N60028_000506
TREASURE ISLAND
SSIC NO. 5090.3.A

SUBJECT: Suggestions and Recommendations to Improve Quarterly Groundwater
Monitoring and Sampling Reports
Related to February 1995 Quarterly Groundwater Sampling Report
Naval Station Treasure Island
San Francisco, California.

**FIGURE
 8**

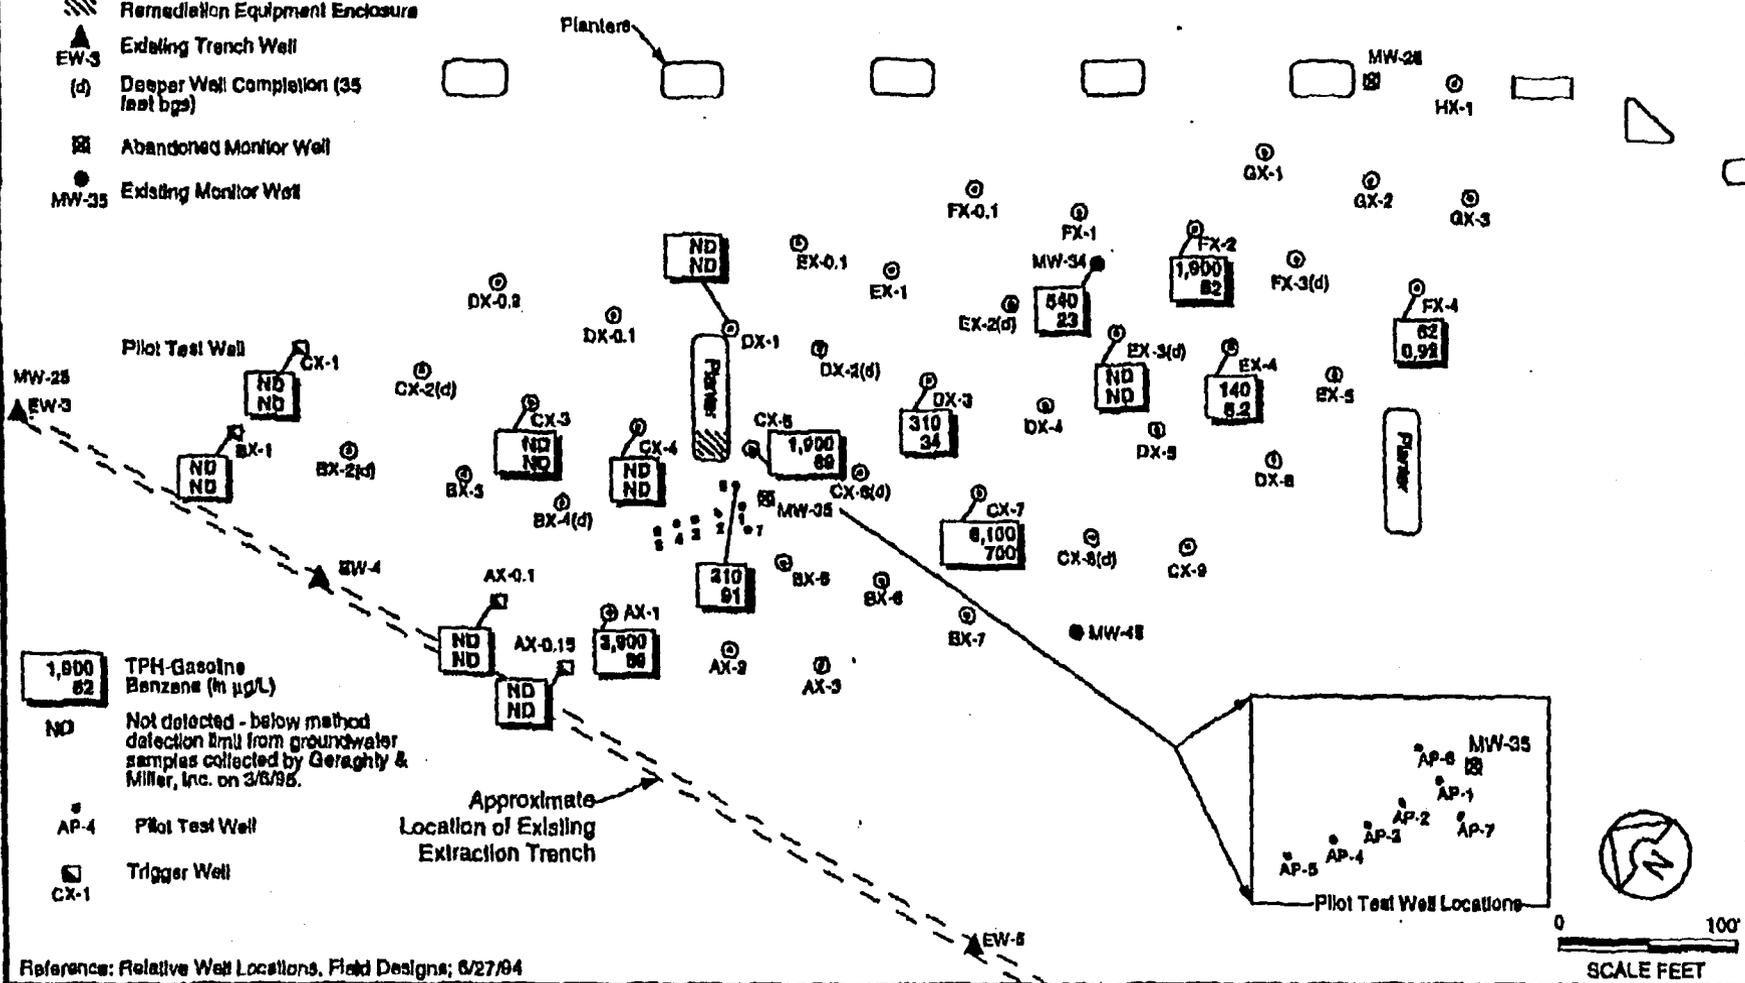
19. I would suggest that the analytical results for the major constituents analysis in the groundwater samples be presented in a figure(s) that will aid the reader in reviewing the data. I would suggest a spider map for either the entire site, or if that map would be difficult to read, spider maps for each of the separate sites. I have enclosed such a map as example Figure 8 for your review. This kind of map makes the data easy to understand and read without forcing the reader to plow through huge volumes of data tables and text. This would help the reader to see where the problem areas are, and by reviewing the spider maps from several different sampling events, it is also easy to see if the concentrations are decreasing or if the particular plume is stable, spreading or getting smaller over time.
